# City of Milton

***RFP 2019.09 – Carpenters Park Phase 1  
Interactive Water Feature (Splash Pad)  
ADDENDUM #1- Additional Information  
November 15, 2019***

# Custom Spin and Spill Fighter Jet

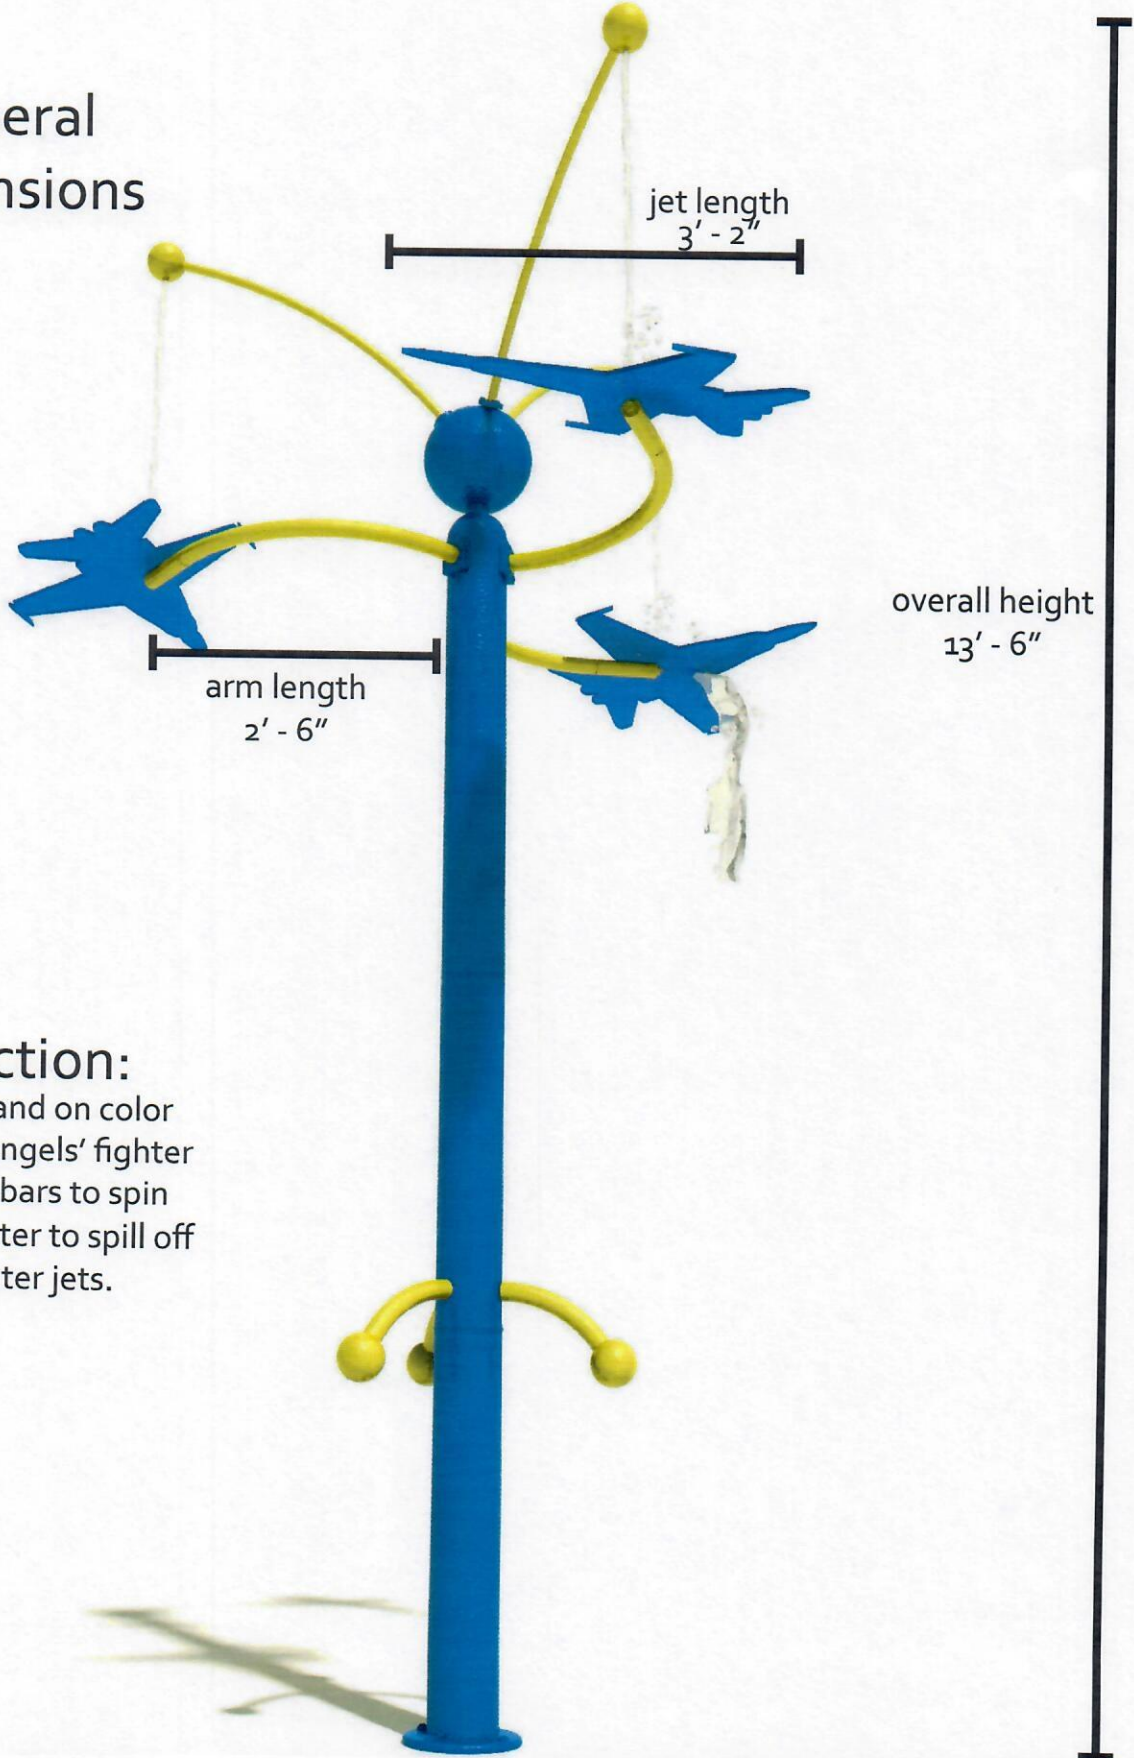
- c. 304 Stainless Steel 360 degrees Rotational Joints with no mechanical stops - design and performance specification
  - d. Custom Spin and Spill Blue Angels Fighter Jet Element – provide design and performance specification and a dimensioned drawing

4. See Attached drawing for “CUSTOM SPIN AND SPILL FIGHTER JET”  
For dimension spill and function references.

water to land on color cast 'Blue Angels' fighter jets, grab bars to spin unit and water to spill off of fighter jets.
